Proposed Change 1807

Code Reference(s):	NFC20 Div.B 2.3.2. (first printing)		
Subject:	Large Farm Buildings (General)		
Title:	Introduction of Requirements for Screens and		
	Curtains Used in Farm Buildings		
Description:	This proposed change introduces flame-testing		
	requirements for screens and curtains used in farm		
- ·			ides options to divide screens and
Polated Code Change	curtains into smaller, non-contiguous areas. CCR 1644		
Related Code Change Request(s):	CCR 1044		
, , ,			
This change could potentially affect the following topic areas:			
Division A	[✓	Division B
Division C	[✓	Design and Construction
Building operations	[Housing
Small Buildings	[✓	Large Buildings
✓ Fire Protection	[✓	Occupant safety in use
Accessibility	[Structural Requirements
Building Envelope	[Energy Efficiency
Heating, Ventilating a	nd Air		Plumbing
Conditioning	[Construction and Demolition
			Sites

Figure [A-2.3.2.4.(2)]

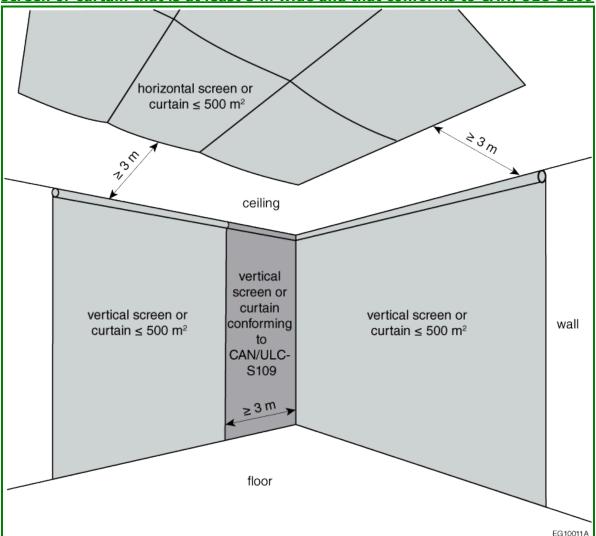
Figure A-2.3.2.4.(2) shows examples of screens or curtains separated, in accordance with Sentence 2.3.2.4.(2), by a distance of at least 3 m (measured from the edge of the horizontal screen or curtain on the ceiling to the uppermost edge of the vertical screen or curtain on the wall) or by a screen or curtain that is at least 3 m wide (measured from the edge of one vertical screen or curtain to the edge of the other vertical screen or curtain) and that conforms to CAN/ULC-S109, "Standard Method for Flame Tests of Flame-Resistant Fabrics and Films."

- G, Division 1, 2 or 3 occupancy shall conform to CAN/ULC-S109, "Standard Method for Flame Tests of Flame-Resistant Fabrics and Films". (See Note A-2.3.2.4.(1).)
- Screens or curtains are not considered to be contiguous for the purpose of Sentence (1) where they are separated by
 - [a] --) a distance of at least 3 m,
 - [b] --) a screen or curtain that is at least 3 m wide and that conforms to CAN/ULC-S109, "Standard Method for Flame Tests of Flame-Resistant Fabrics and Films," or
 - [c] --) a fire separation having a fire-resistance rating of at least 45 min. (See Note A-2.3.2.4.(2).)
